DEVIATIONS TO APPROVED PLAN NO. C/129 04 13.

PROJECT
DEVIATION TO APPROVED PLAN NO. C/129 04 13 FOR PROPOSED ADDITIONS AND ALTERATIONS FOR MR RICHARD HYATT ON ERF 1492, 9 GROSVENOR CRESCENT, DURBAN NORTH

DRAWING TITLE
GROUND STOREY PLAN, FIRST STOREY PLAN AND DEVIATION LEGEND

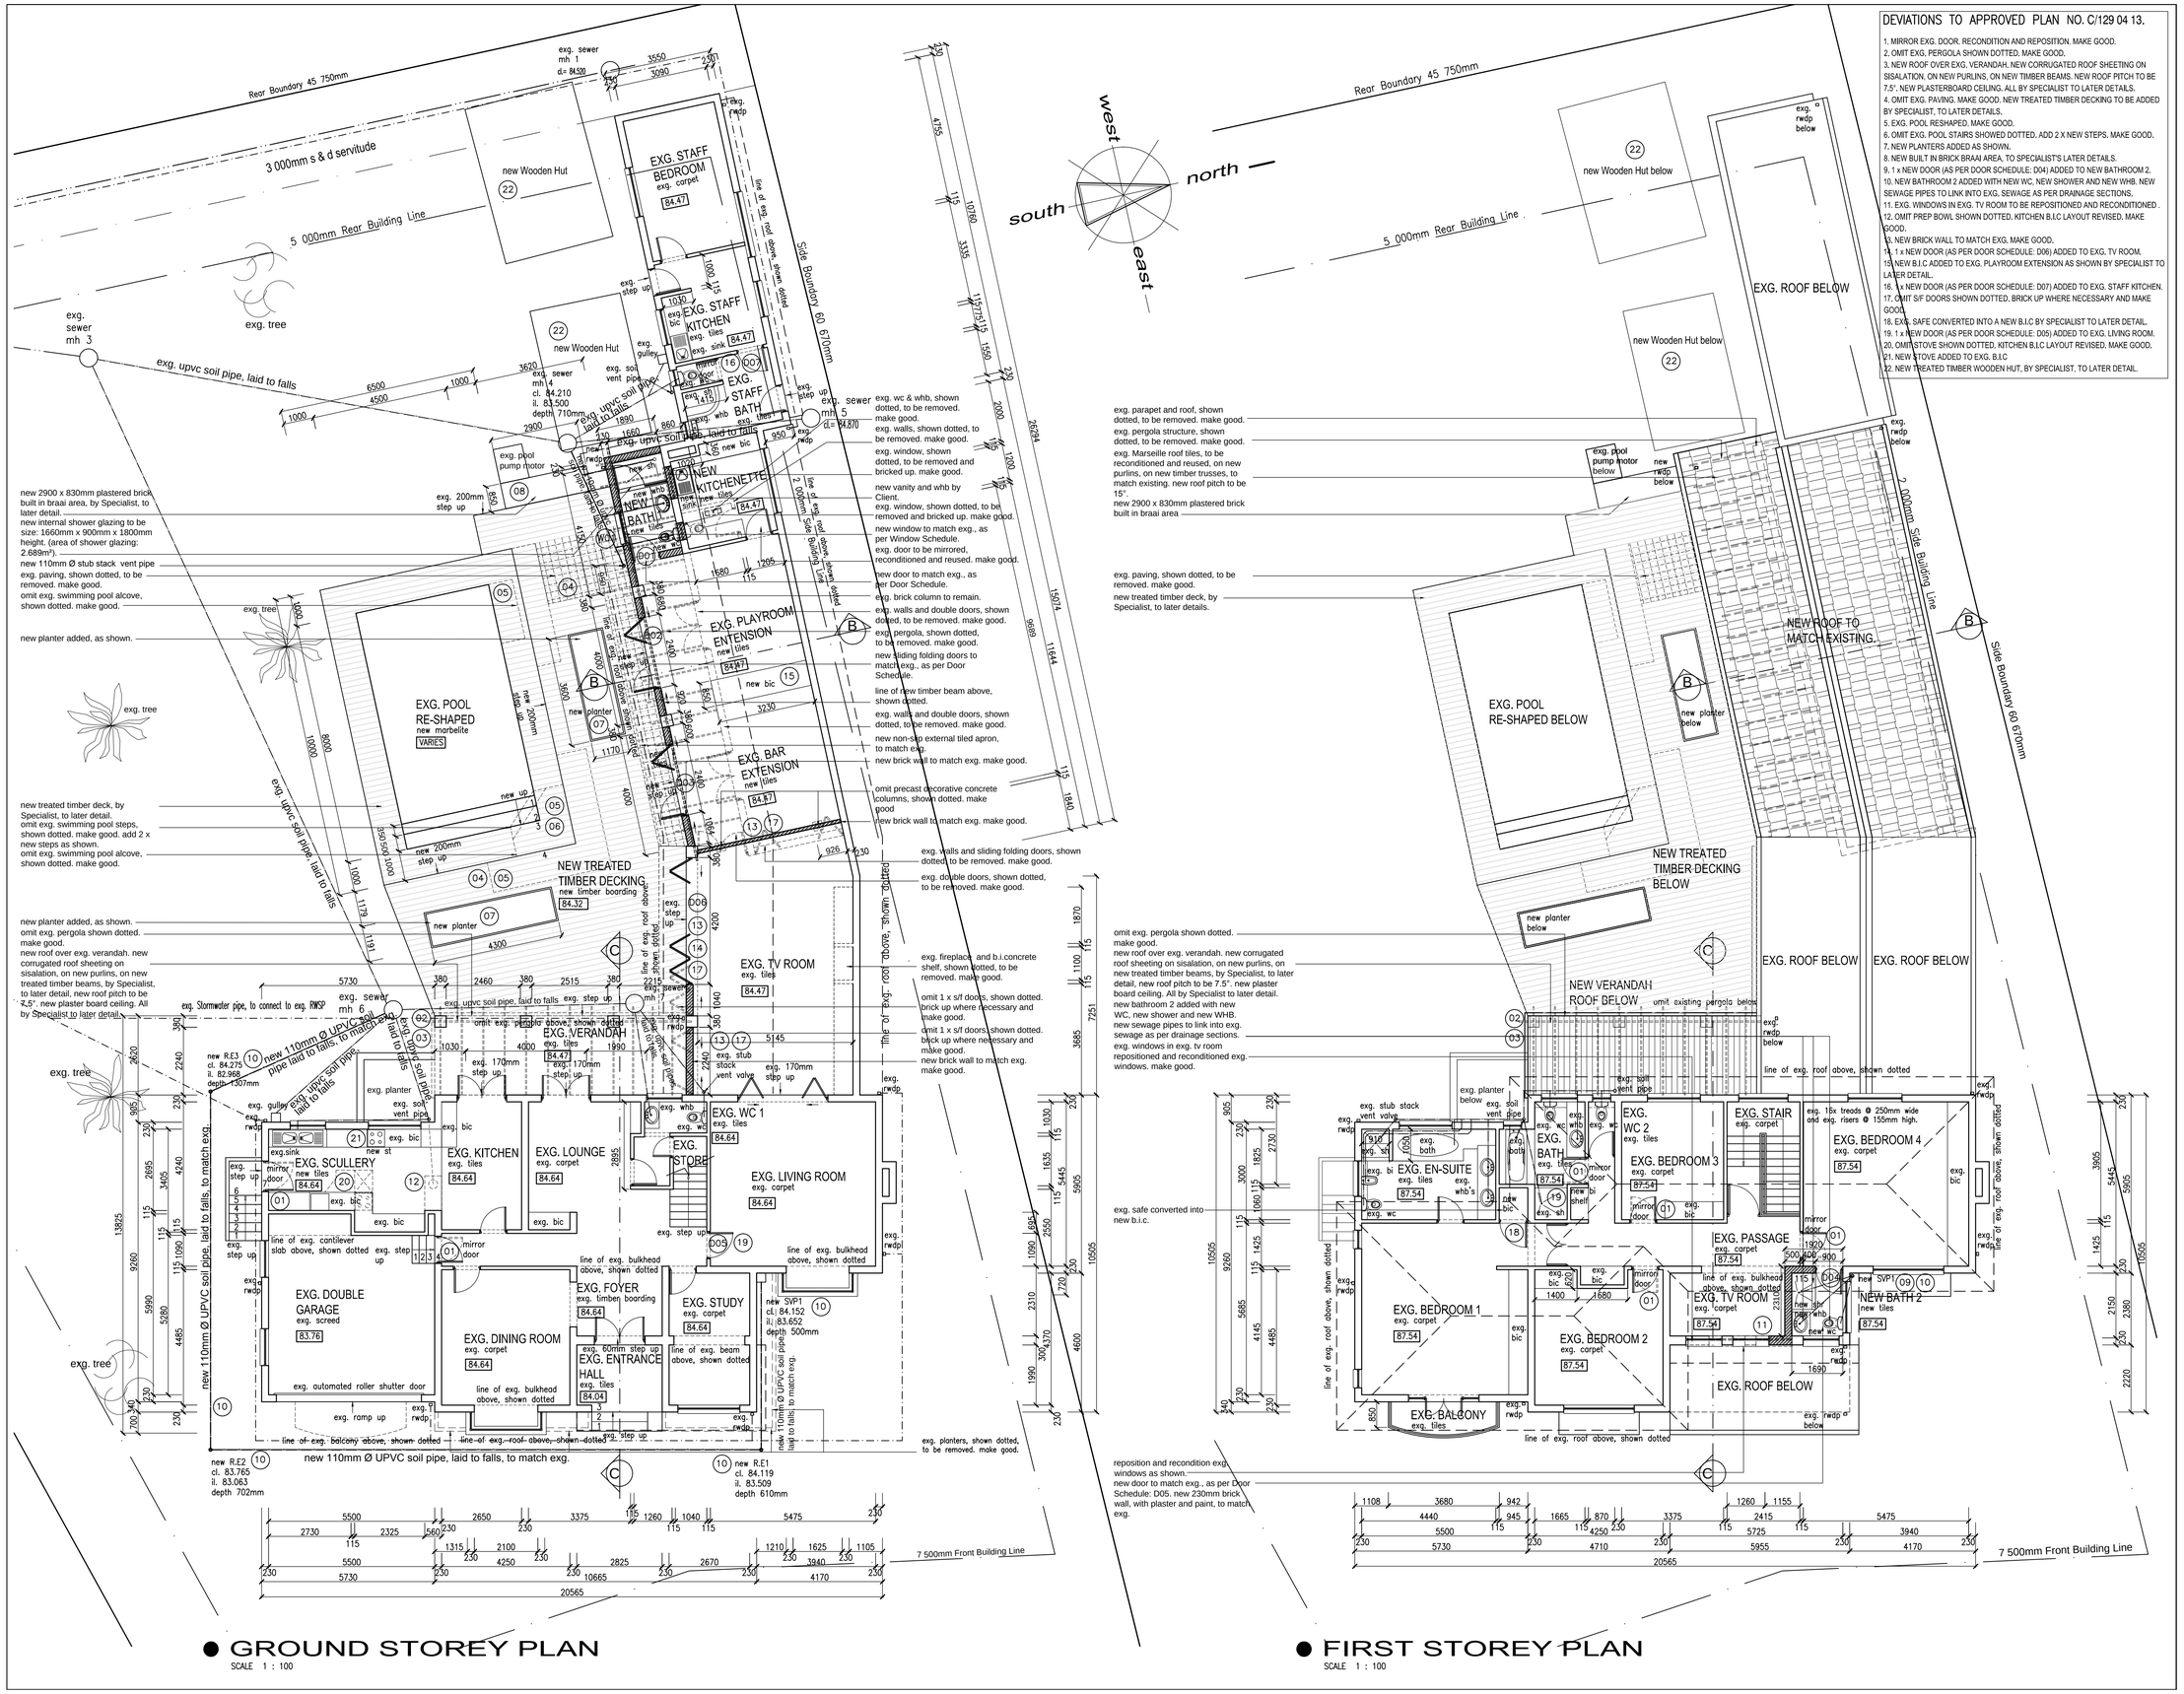
1. MIRROR EXG. DOOR. RECONDITION AND REPOSITION. MAKE GOOD.
2. OMIT EXG. PERGOLA SHOWN DOTTED. MAKE GOOD.
3. NEW ROOF OVER EXG. VERANDAH. NEW CORRUGATED ROOF SHEETING ON SISALATION, ON NEW PURLINS, ON NEW TIMBER BEAMS. NEW ROOF PITCH TO BE 7.5°. NEW PLASTERBOARD CEILING. ALL BY SPECIALIST TO LATER DETAILS.

4. OMIT EXG. PAVING. MAKE GOOD. NEW TREATED TIMBER DECKING TO BE ADDED BY SPECIALIST, TO LATER DETAILS.
5. EXG. POOL RESHAPED. MAKE GOOD.
6. OMIT EXG. POOL STAIRS SHOWED DOTTED. ADD 2 X NEW STEPS. MAKE GOOD.

7. NEW PLANTERS ADDED AS SHOWN.
8. NEW BUILT IN BRICK BRAAI AREA, TO SPECIALIST'S LATER DETAILS.
9. 1 x NEW DOOR (AS PER DOOR SCHEDULE: D04) ADDED TO NEW BATHROOM 2.

10. NEW BATHROOM 2 ADDED WITH NEW WC, NEW SHOWER AND NEW WHB. NEW SEWAGE PIPES TO LINK INTO EXG. SEWAGE AS PER DRAINAGE SECTIONS.
11. EXG. WINDOWS IN EXG. TV ROOM TO BE REPOSITIONED AND RECONDITIONED .

12. OMIT PREP BOWL SHOWN DOTTED. KITCHEN B.I.C LAYOUT REVISED. MAKE GOOD.
13. NEW BRICK WALL TO MATCH EXG. MAKE GOOD.
14. 1 x NEW DOOR (AS PER DOOR SCHEDULE: D06) ADDED TO EXG. TV ROOM.

15. NEW B.I.C ADDED TO EXG. PLAYROOM EXTENSION AS SHOWN BY SPECIALIST TO LATER DETAIL.
16. 1 x NEW DOOR (AS PER DOOR SCHEDULE: D07) ADDED TO EXG. STAFF KITCHEN.

17. OMIT S/F DOORS SHOWN DOTTED. BRICK UP WHERE NECESSARY AND MAKE GOOD.
18. EXG. SAFE CONVERTED INTO A NEW B.I.C BY SPECIALIST TO LATER DETAIL.
19. 1 x NEW DOOR (AS PER DOOR SCHEDULE: D05) ADDED TO EXG. LIVING ROOM.

20. OMIT STOVE SHOWN DOTTED. KITCHEN B.I.C LAYOUT REVISED. MAKE GOOD.
21. NEW STOVE ADDED TO EXG. B.I.C
22. NEW TREATED TIMBER WOODEN HUT, BY SPECIALIST, TO LATER DETAIL.
